# CITY OF ALBUQUERQUE

**RE: 439 Narcissus SE**  
**Request for Pad Certification - Accepted**  
**Certification Dated: 8/15/19**  
**Grading Plan Stamp Date: 8/7/19**  
**Drainage File: L23D031**

## DRAINAGE AND TRANSPORTATION INFORMATION SHEET (REV 6/2018)

ENGINEER'S SEAL	LOT 6-A-1, BLK 2 NORTH FOUR HILLS SUB 439 NARCISSUS PLACE	DRAWN BY DEM
DAVID SOULE NEW MEXICO REGISTERED PROFESSIONAL ENGINEER 14522	GRADING AND DRAINAGE PLAN	DATE 8-7-19
		LOT 6-A-1, BLK 2 NORTH FOUR HILLS SUB DIVS
8/7/19	Rio Grande Engineering 1608 CENTRAL AVENUE SE SUITE 201 ALBUQUERQUE, NM 87106 (505) 972-0899	SHEET # C1
		JOB #

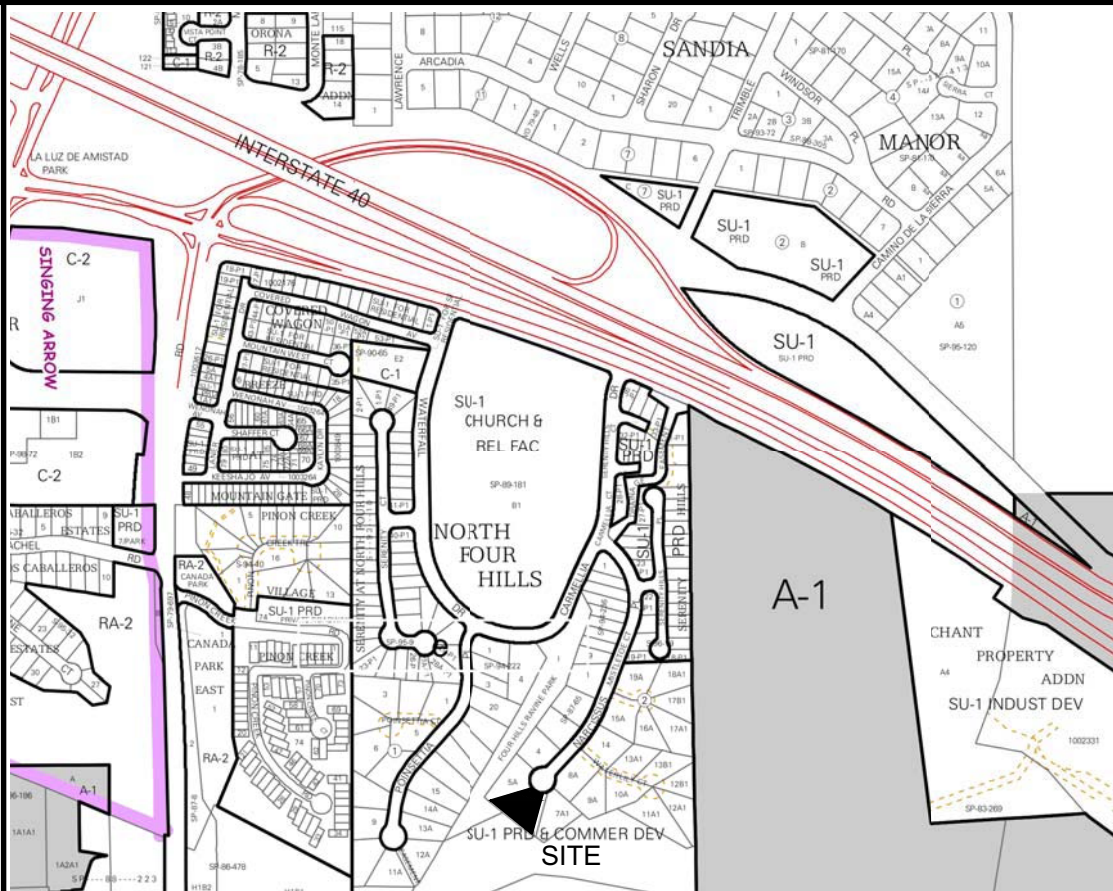
Based on the submittal received on 8/19/19, this Pad Certification is approved for Building Permit.
